# 2023/2958/P - Plot R8 King's Cross

<b>Delegated Report</b>		Analysis sheet		Expiry Date:	16/11/2023
(Members Briefing)		N/A		Consultation Expiry Date:	19/08/2023
Officer			Application Number(s)		
Edward Hodgson			2023/2958/P		
Application Address			Drawing Numbers		
Plot R8 King's Cross Central York Way London			See draft decision notice		
PO 3/4	Area Team Signature	e C&UD	Authorised Officer Signature		
Proposal(s)		l	I

Amendments to reserved matters approval ref 2020/5143/P dated 09/02/2021 (Reserved matters relating to Building R8 for the erection of two, 13 storey buildings comprising office space (Class B1) and 72 Social Rented Affordable residential units, as required by conditions 9, 10, 12, 14, 16-22, 24, 27, 28, 31, 33-39, 42, 42A, 43, 45, 46, 48, 49, 50A, 51, 56, 60, 61, 64-67 67 of outline planning permission reference 2004/2307/P granted 22/12/06 (subject to S106 agreement) for a comprehensive, phased, mixed-use development of former railway lands within the King's Cross Opportunity Area) namely, alterations to windows, doors, ducts and louvres on the approved facades, alterations to the landscaping and location of PV panels.

Image 3. North elevation as proposed

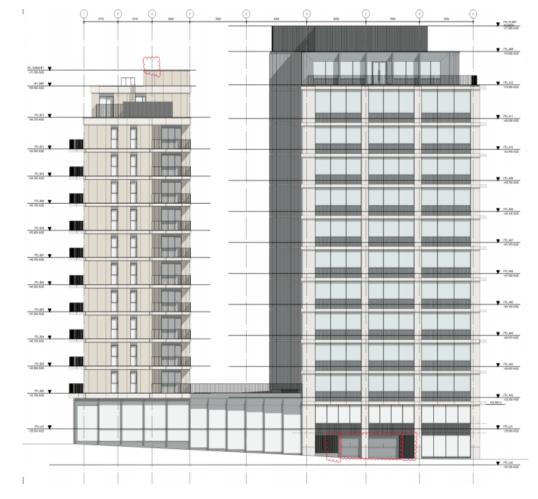
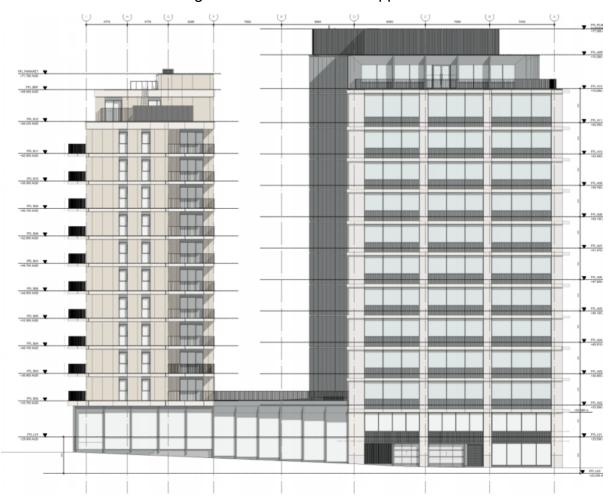
- 1.2 The proposed amendments can be summarised as follows:
  - <u>North elevation:</u> Omission of decorative screen to louvres, new access door at ground floor, new car park doors opening system, and reinstatement of altered fresh air duct.

- 2.3 At ground floor level, it is proposed to remove the approved decorative screen to the substation ventilation louvres to improve the quality of ventilation by being less restrictive. In addition, the approved loading bay doors would be amended to be perforated to allow for more ventilation into the substation. A new access door is proposed which would be integrated into the design of the ground floor façade, and would be almost imperceptible when viewed from the public realm. The ground floor changes are considered to be in keeping with the design and appearance of the overall buildings and given the scale of the approved buildings, they would not detract from their appearance.

- 2.4 The fresh air duct that was approved in the original reserved matters application (2020/5143/P) would be reinstated albeit 0.3m higher than the one originally approved. Given its location at roof level, the duct would have limited visibility in views from the public realm and would not add significant visual clutter to the roof.

Image 11: Second floor landscape podium as proposed

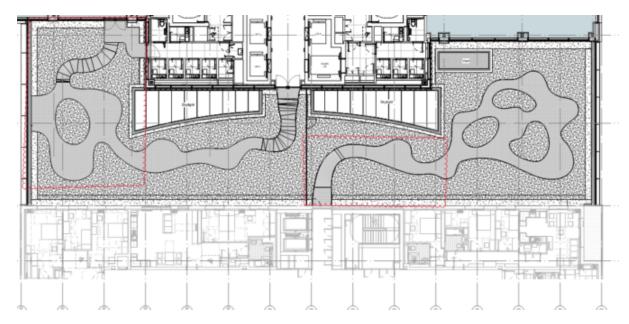
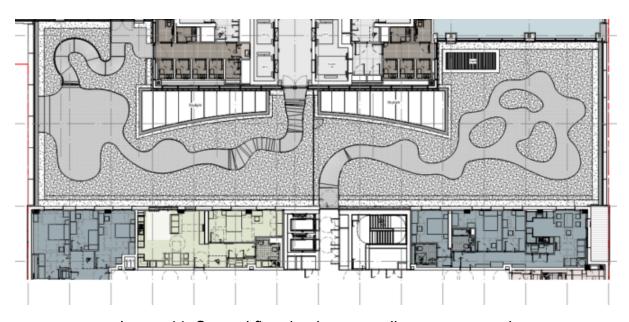
2.12 The landscaping on the second floor podium would be adapted to increase the amount of hard landscaping compared to soft landscaping, following the previous amendments in application 2022/1892/P which allowed for new office doors onto this landscaped area. The changes would mean that water on the paths would drain on to the soft landscaping areas. There would not be a significant increase in the amount of hard landscaping and a sufficient amount of soft landscaping would be retained and the changes are thus considered acceptable. No approved trees would be removed as part of the proposals, and as such the amendments would be in accordance with the requirements of condition 9.

Image 13: Commercial building roof plan as proposed

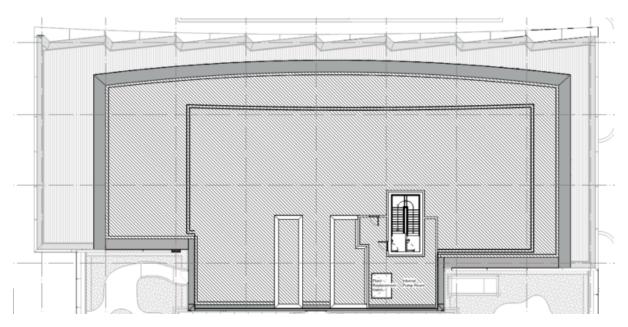
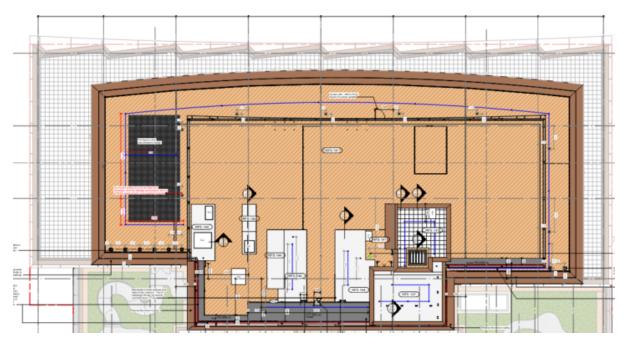
2.11 It is proposed to move the approved PV panels from the roof of the residential building to the roof of the commercial building. The panels would serve both buildings. The PV panels would be set back behind the parapet on the flat roof of the commercial building and would have very limited visibility in views of the public realm. They would therefore not impact on the overall appearance of the commercial building and are considered acceptable.
